MVSC/AA-180/260/300/460 , MVSD-260/300

Series Solenoid/Pilot Valve

Pneumatic Symbol Position Design Change Notice

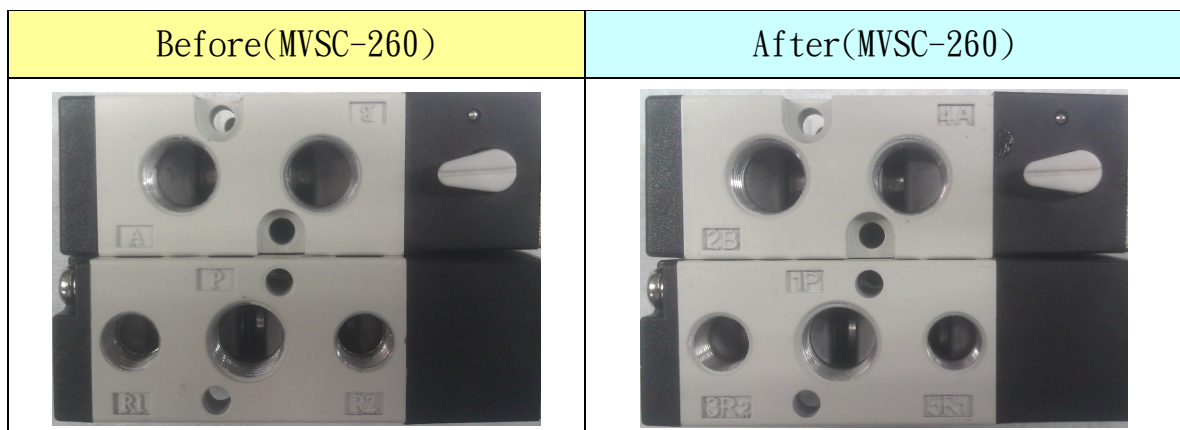
i. Adding ISO Pneumatic symbol

MVSC/AA-180/260/460 , MVSD-260/300	
Before	After
P	1P
B	2B
R2	3R2
A	4A
R1	5R1

ii. 4A and 2B would switch the position, so do 3R1 and 5R2.
